RE: Response to Technical Evaluation Comments and Information Request of CES's Responses to EPA's Initial Technical Evaluation Comments and Information Requests #1-4 CES-Mendota Site Underground Injection Control (UIC) Permit Application Class VI Pre-Construction Permit Application No. R9UIC-CA6-FY20-1

### Evaluation of Applicant Responses to EPA’s Technical Review Comments on the Geologic Information in the CES-Mendota Class VI Permit Application

Figure 2a and 2b: San Joaquin basin depositional model showing three possible depositional scenarios for the location of Mendota\_INJ\_1. Modified from (Hosford Scheirer & Magoon, 2007)

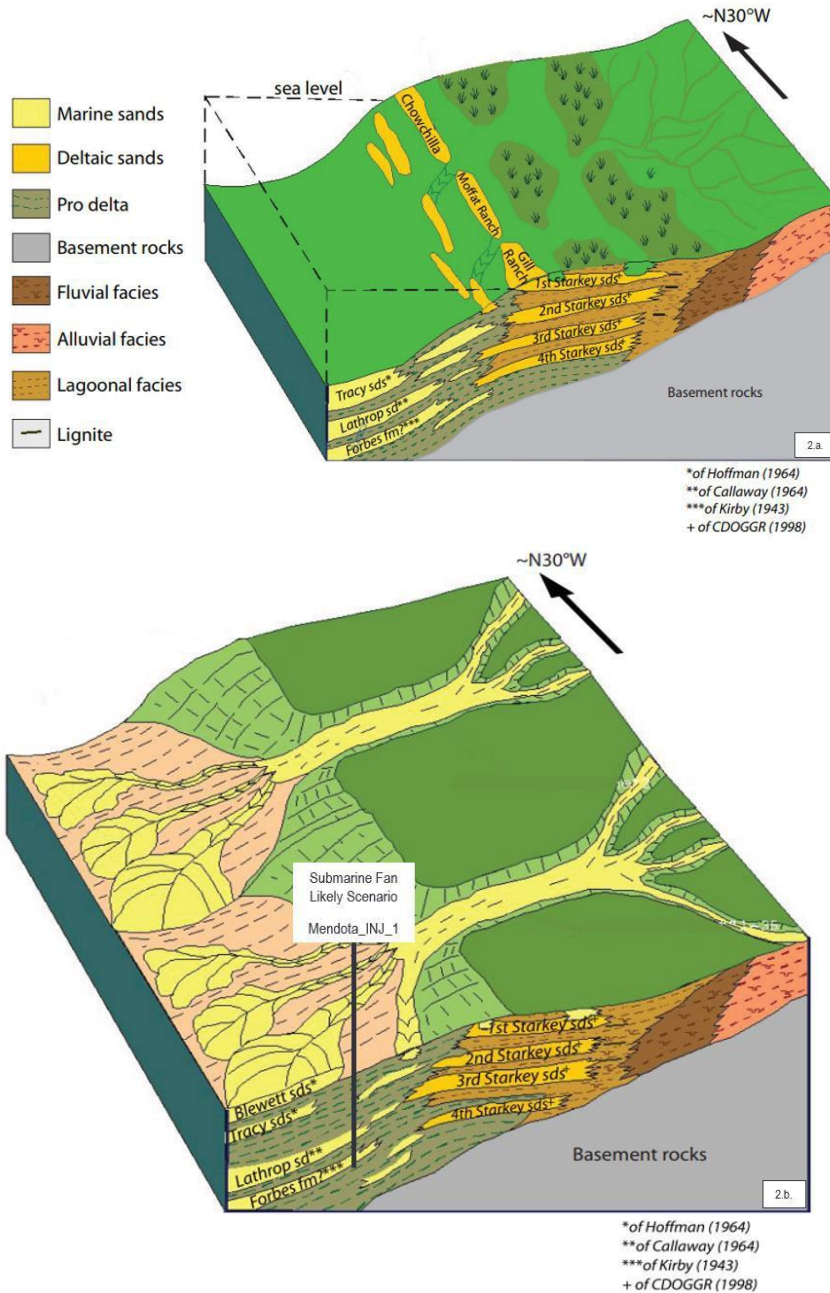
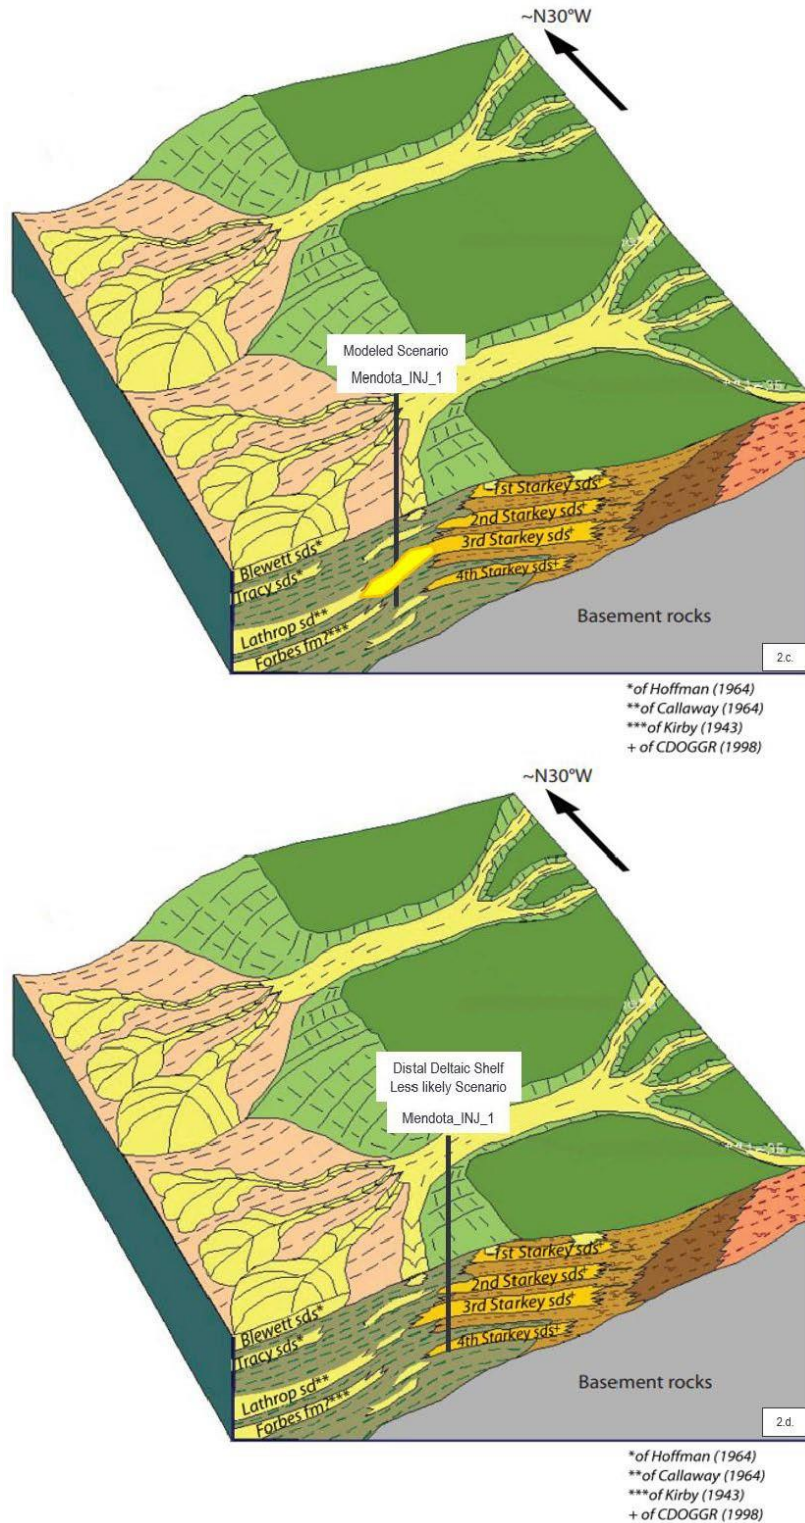
- The Mendota\_INJ\_1 well location in Figures 2a–2d is supposed to be the same location. The series of diagrams intends to demonstrate the possible depositional environments that Mendota\_INJ\_1 could encounter. It is also intended to show that a conservative model (one in which all sands are modeled as one flow unit, posing the greatest leakage risk, Figure 2c was pursued for preliminary site characterization due to lack of site-specific data.

- Is the 2nd Starkey the same as the 2nd Panoche? If so, then is it coeval with the Tracy sands? The diagram in Figure 2c (modeled scenario) shows the well penetrating the level of the 3rd Starkey. In the “likely scenario” in Figure 2b, it appears that the well goes as far down as the level of what might be the 4th Panoche sand. Although the 3rd and 4th Panoche sands are potential injection scenarios, should the diagrams in Figures 2a-2d represent the planned injection into the second Panoche?

The following text will be added to the Regional Geology section of the revised narrative attachment to add clarification regarding stratigraphy of the proposed storage complex. This summary should clarify the stratigraphic description and adequately answer questions posed.

Figure 3: Porosity-permeability crossplot model cells colored by formation (from Petrel 2019).

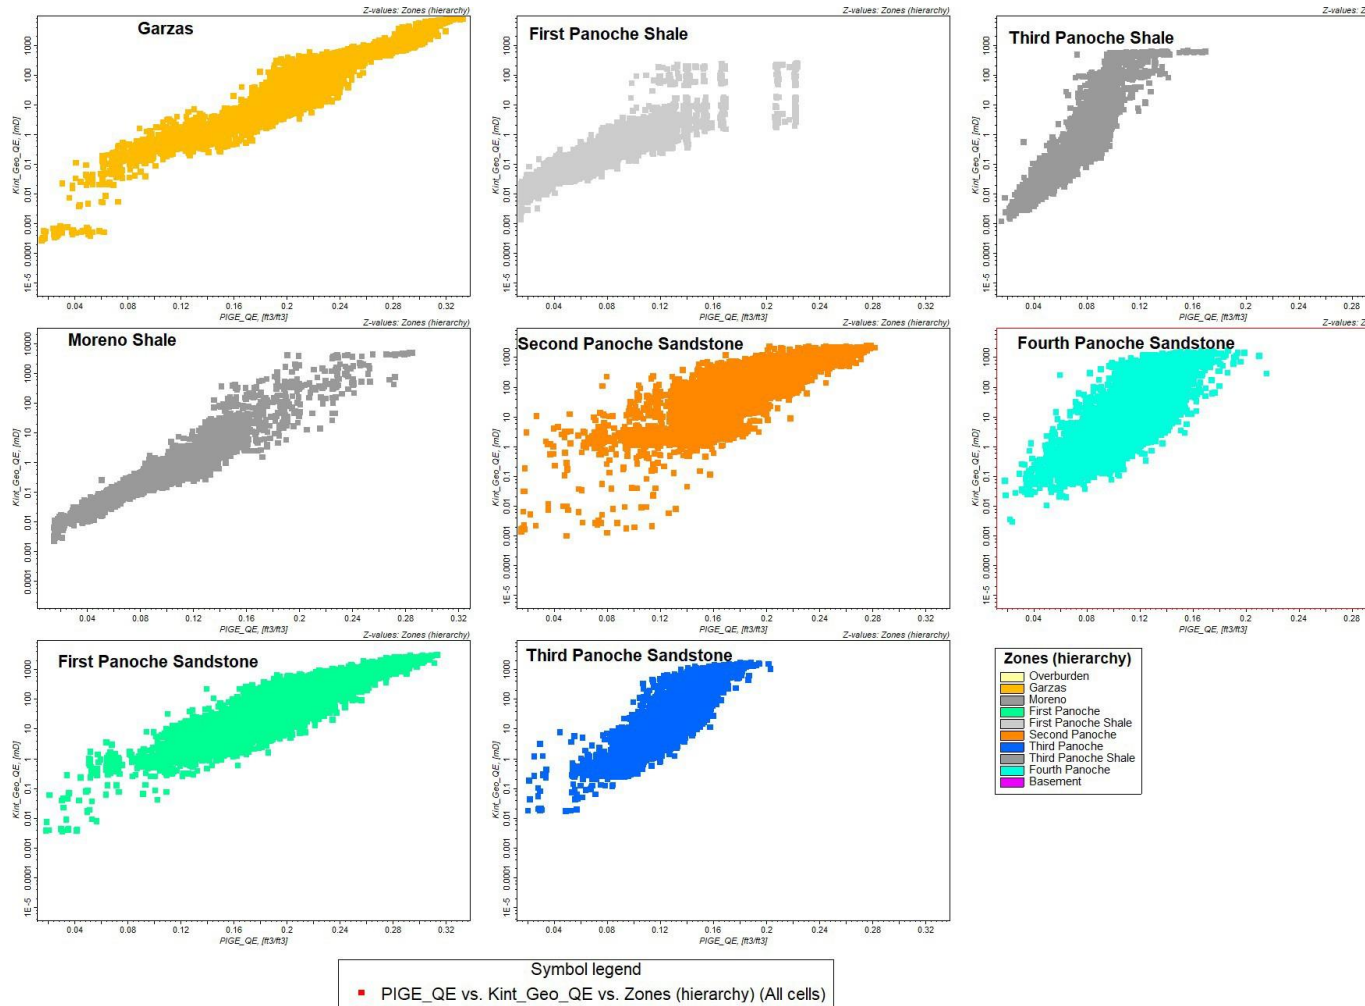
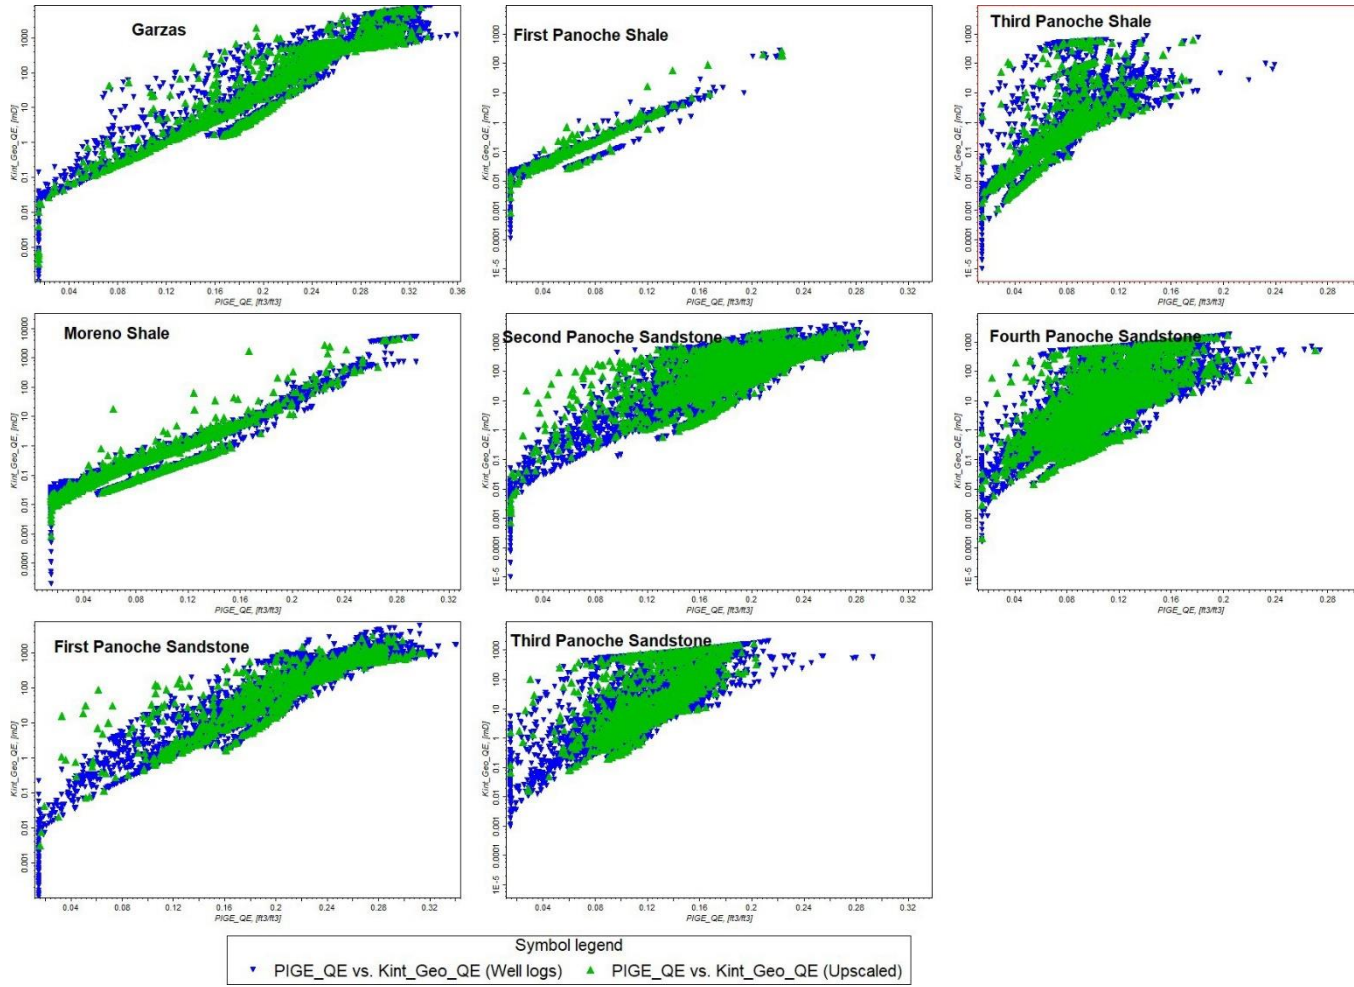
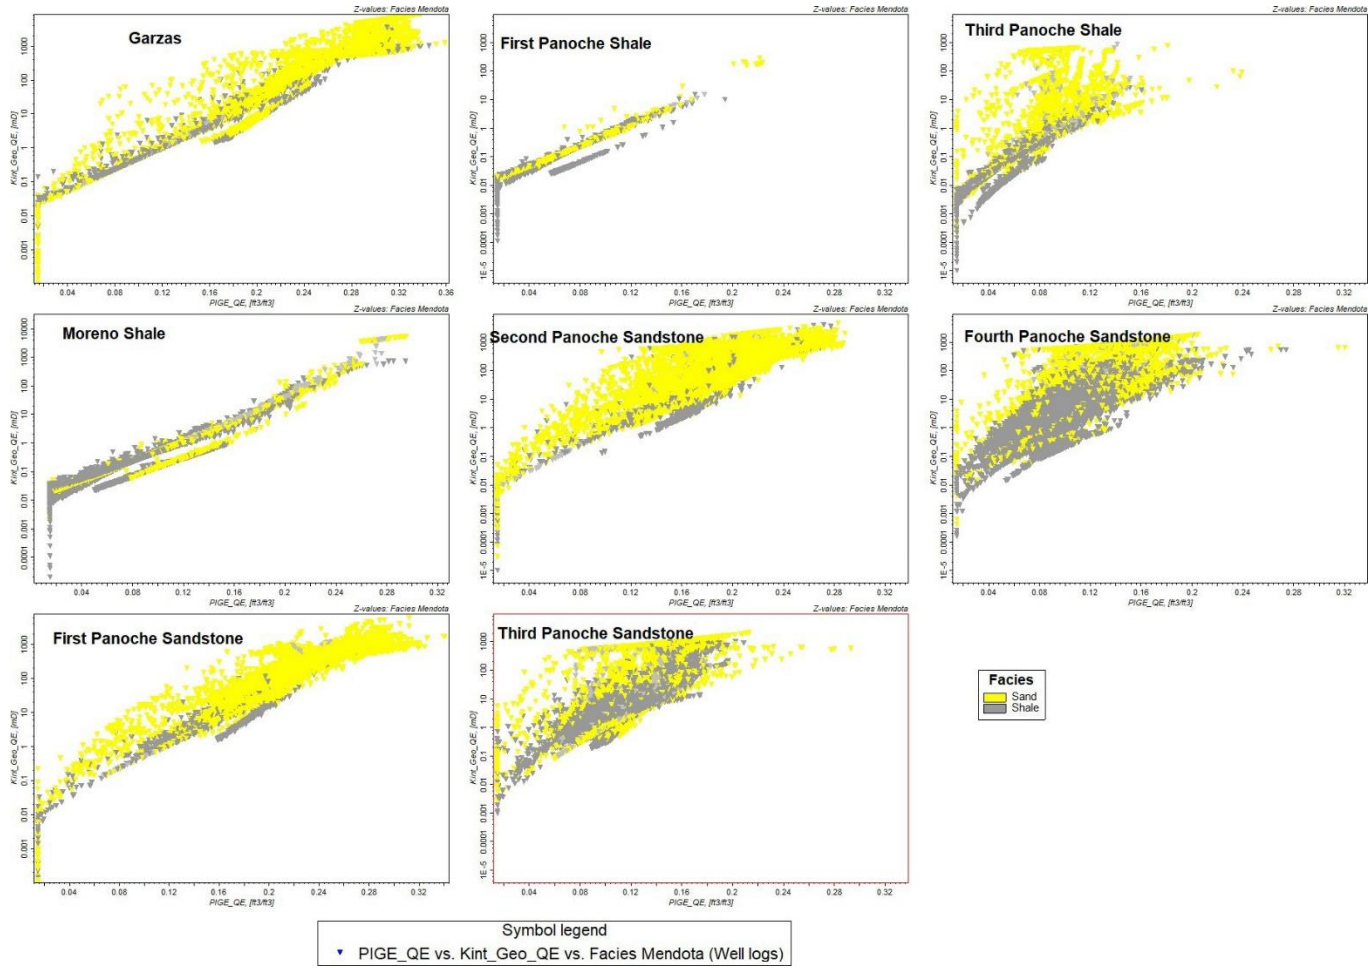
- In the plot of well log-derived data points, upscaled values, and full-field simulated cells, the upscaled values dominate. It appears that the upscaled value symbols may have been layered over the other symbols. Please revise the figure to show the distributions of all three types of data points more clearly.
  - *For clarity, Figure 30 has been subdivided into three figures. Please refer to Figure 3, Figure 4, and Figure 5 in Appendix A.*

- Please clarify the meaning of the zones in the legend of Figure 30. Are they equivalent to the formations, as suggested by the legend?
  - *Zones are equivalent to formations. For clarity, Figure 30 has been updated and divided into Figure 3, Figure 4, and Figure 5 in Appendix A.*

- Were the graphs in Figure 30 the basis for assigning phi and k in the layering in the model domain?
- *For clarity, Figure 30 has been updated and divided into Figure 3, Figure 4, and Figure 5 in Appendix A. The graphs show the unique porosity/permeability relationships per zone. The corresponding variables were used in the layering model.*

Figure 6. Rock types along the E-W cross section (from Petrel 2019).

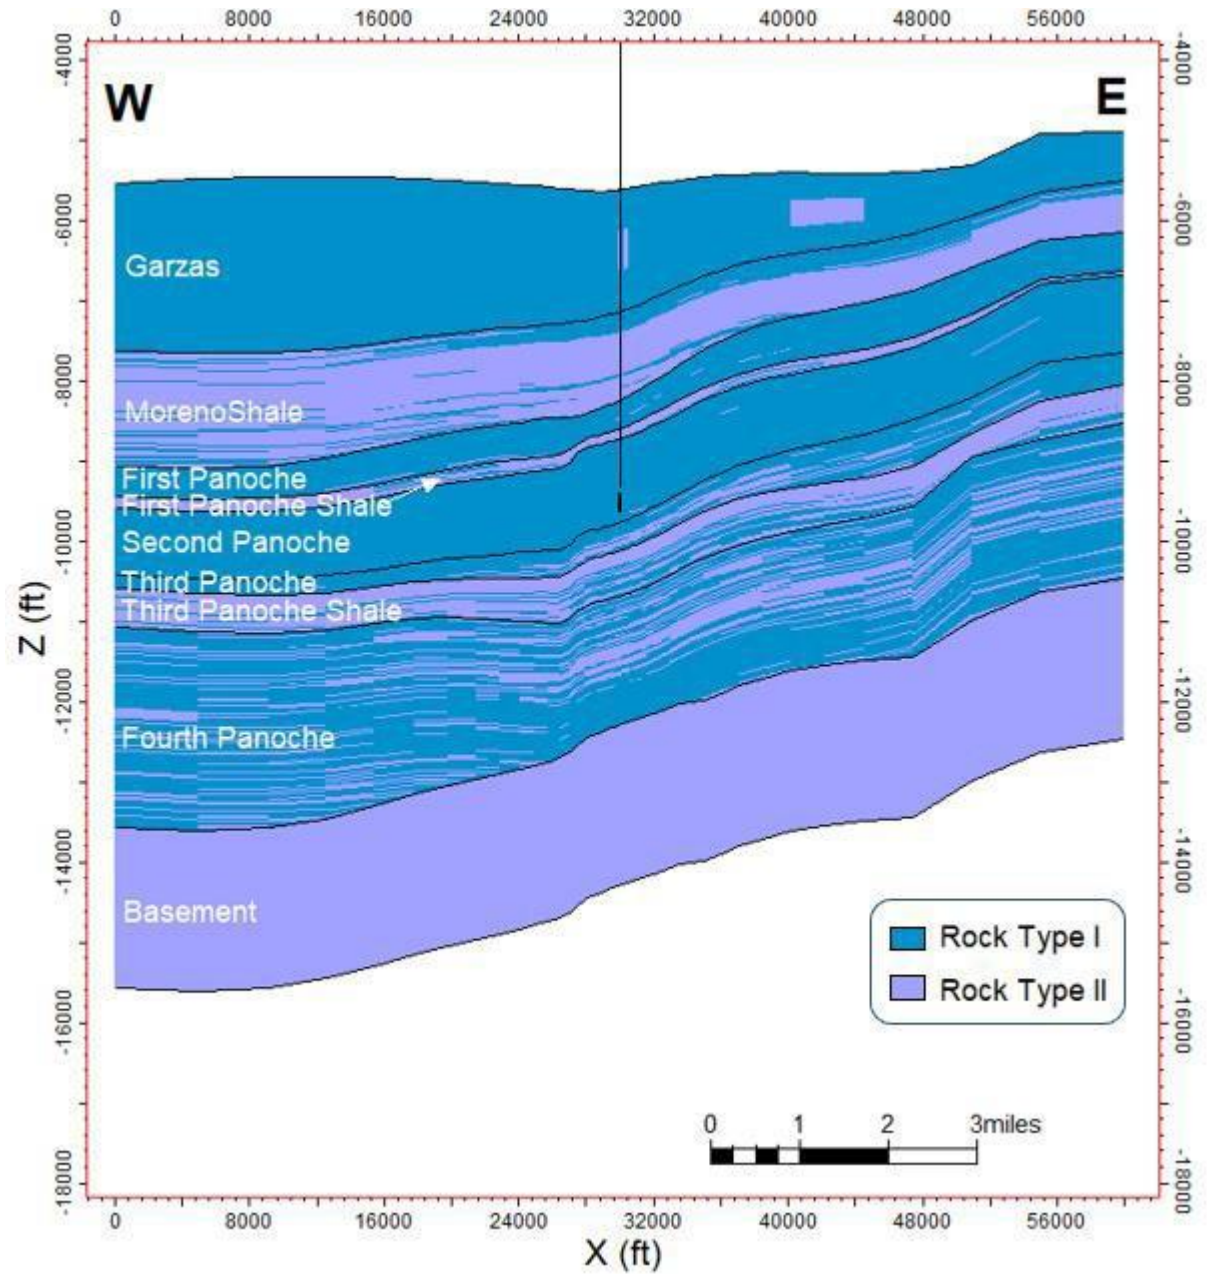
- Is there a difference between the two shades of blue in Figure 2 of the Rock Types file?
  - *No, the different blue shades are due to the presence of grid lines shown on the figure. Refer to Figure 6 in Appendix A for an updated version.*

- Please label the formations in Figure 2.
  - *Refer to Figure 6 for an updated version of Figure 2 in Appendix A which includes the formation names.*
